☒ CTL Provisional DECISION SHEET (PDSH)
☐ CTL DECISION SHEET (DSH)

Standard(s) (incl. year)	Subclause(s)	Tracking No.
IEC 60598-1:2020	7.2	2275
Category		
LITE		
Subject	Keywords	Provided to
Earth connection	Earth connection	ETF 5

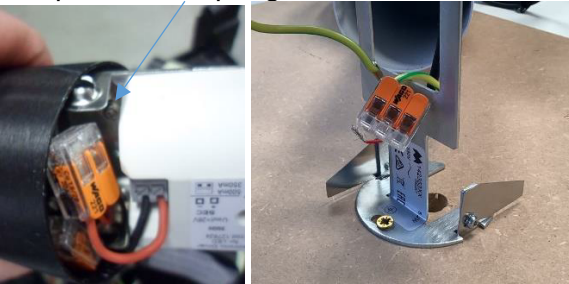
Question		
Are the following constructions acceptable ?		
<div></div> <p>The earthing connection for the metal bar which is fixed by screw to the ceiling is made by 2 screw on each side. The force of the screws will make the connection . Can we consider this as permanently and reliable ? Or is an additional connection needed by screws or other means which are more reliable ? For a class I luminaire which is fixed to the ceiling a cover is used to protect the basis insulating parts. This cover is not fixed by screws but by a couple of springs (Min 2) in the first picture the springs scratch into the metal of the cover. On the 2nd picture it doesn't.</p> <div></div> <p>In 7.2.1 earthing contact shall be permanently and reliably connected to a protective earthing terminal or protective earthing</p> <p>Question 1: Are The 2 examples of springs like these above considered as permanent earthing contact if it complies with 8.2.6 and can withstand force of 20N perpendicular to the mount surface. Question 2: If not can these be considered as screwless terminals and be tested to §15. Question 3: Can fix metal cutters which as pushed into the metal part of the cover, be used as permanent earth connection. If they comply with 8.2.6 (20N) See illustration below.</p> <div></div>

Decision
These kind of earthing connections are acceptable if the §7.2.1+ §7.2.3 for screw connection are fulfilled
Explanatory notes
<u>Enquiry: OSMLUM ETF 5 minutes §9.1.6 2024</u> Date: May 23th 2024
<u>PDSH:</u> Year of publication: To be approved at CTL plenary:
<u>DSH</u> Publication date:
Click here to enter text.
